APPLICATION FOR AN IMPROVEMENT PERMIT

HEALTH DEPARTMENT
ENVIRONMENTAL HEALTH DIVISION
1200 BLYTHE BOULEVARD
CHARLOTTE, NC 28203
PHONE (704) 376-4603

RE: Property located at 11535 Shopton Road West

PHYSICAL SURVEY

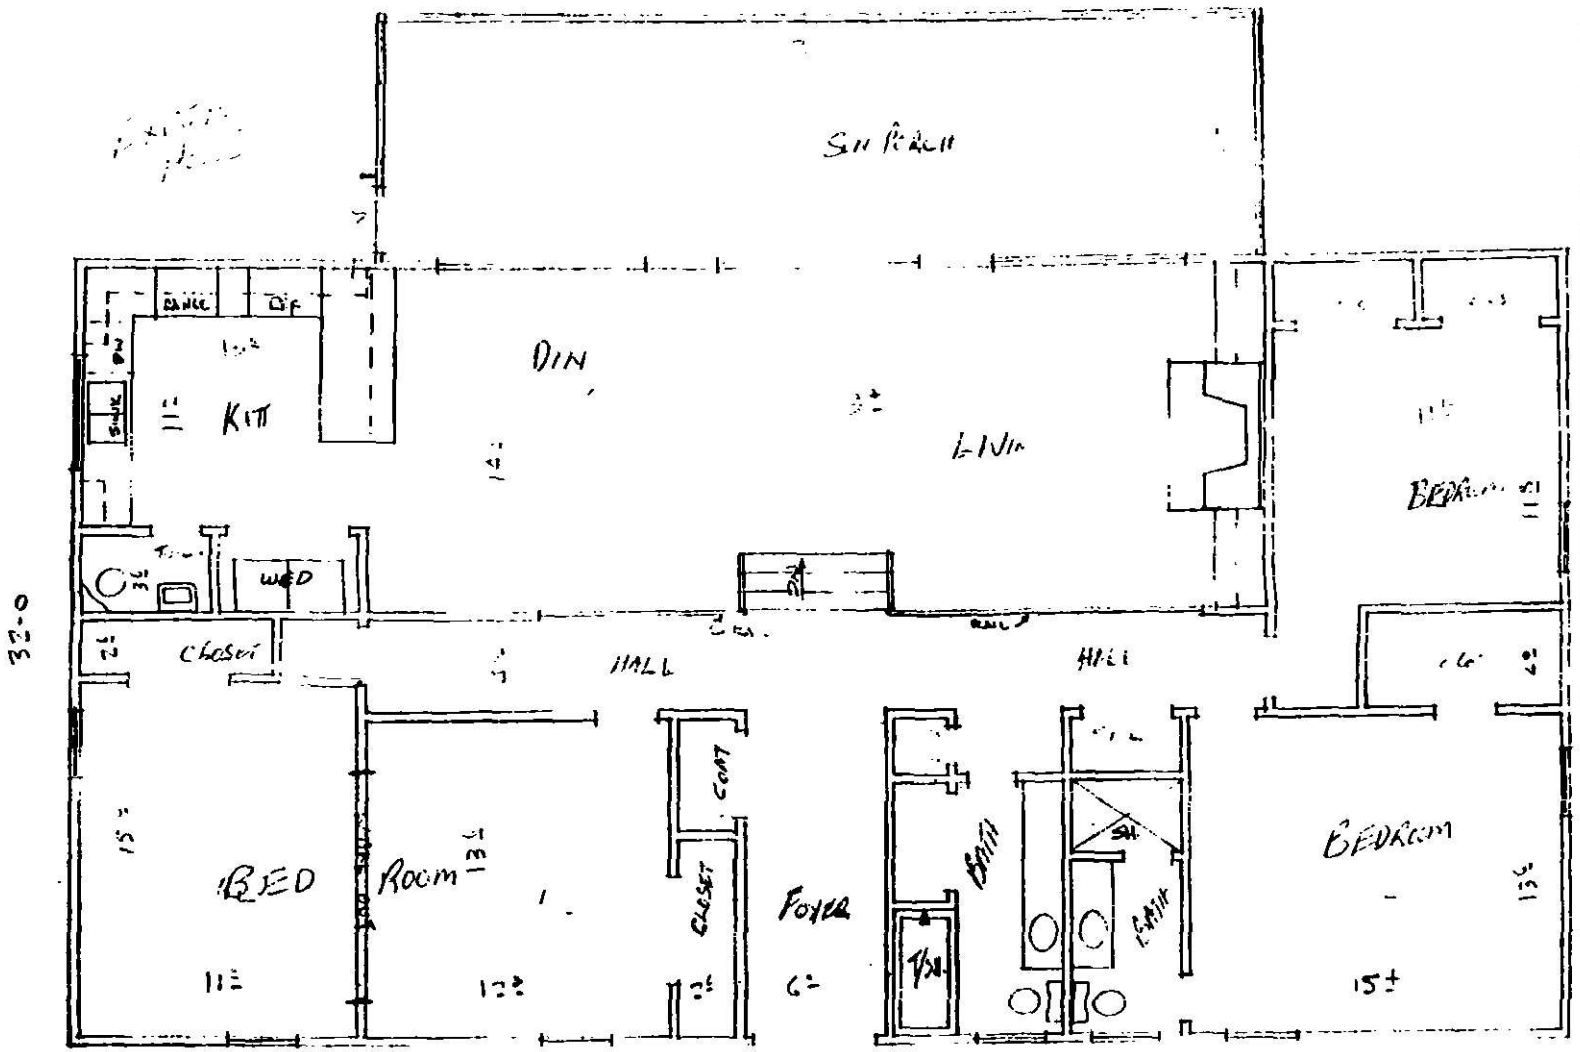
In order to add to the existing house, the present septic tank and a portion of the septic drainfield must be moved from its present location to another area.

A sanitary sewage system shall be located at least the minimum horizontal distance from the following:

1. Streams or other surface waters--50 feet from the high water mark. This is a major consideration on this lot.

2. Any basement--15 feet.

3. Any property line--10 feet.

Due to these restrictions there is insufficient space to accommodate any additions to the existing house. Therefore, your application for a permit is denied. If you have any questions, please call (704) 336-4803.
